Our ref: 2024/1216/PRE Contact: Nick Baxter Direct line: 020 7974 3442

Re: 15 Church Row NW3 6UP

Internal alterations on both floors and minor external alterations on the second floor

Roof

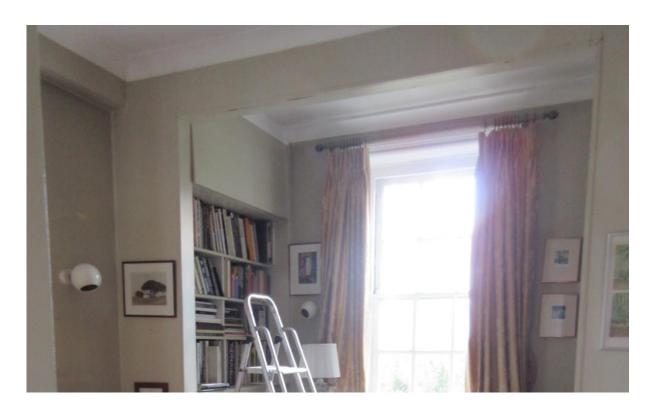
The rear of the house is prominently visible from Frognal Way and the south. It is unlikely that this house had any form of roof terrace when built. Therefore, the visible presence of a roof terrace is atypical and harmful, both to the listed building and the conservation area, and should be reduced, not increased.

The existing inset dormer arrangement on the roof has full-height sliding aluminium patio doors, with glazed returns and glazed spandrel panels at floor level. It is ayptical and prominent and therefore undesirable, and attempts to enlarge it would be unwelcome. However, it may be possible to improve the existing design while inserting a modest dormer. Bringing the plane of glazing forward would at least eliminate the glazed returns. Improvements could include reducing the glazed area and breaking up the glazing into smaller panes. Any dormer would need to be traditionally detailed. The aluminium patio doors envisaged would not be considered an improvement.

However, it will need to be explained why the terrace deck is at the height it is. It seems improbable that whoever built the opening decided to raise the newly accessible terrace to a level higher than the room it served; if anything, given the choice, it would be normal to have it lower. This suggests that the deck level represents the house's original eaves height and as such will form an integral part of the roof as a whole.

This leads to the possibility that the level of the terrace deck is in some way related to the height of the room in the bay below. The square bay on the first floor has a structural crossmember apparently at the position where the attic room has a step, lending credence to this theory. Any works to the terrace deck level that entail structural alterations will be unacceptable.

The satellite dishes should be removed. The awning is a discordant and noticeable feature at high level and should be removed.

It is likely that a plain metal handrail will be acceptable. The lowering of the terrace deck will have the effect of reducing its necessary height.
